PCN No.: PCN # 033

Product Change Notice: XPort Firmware Version 6.1

Revision Tracking Information on XPort Label

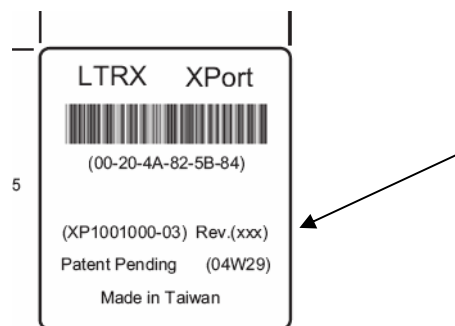
For quality and tracking purposes, the manufacturing revision numbers on the product label will be changed. New revision numbers are also listed in the table.

Please note that the revision information for the XPort product is as shown below:

XPort factory shipments with firmware 6.1.0.0 will begin January 31, 2006. The firmware version can be verified by examining the label for the product revision number.
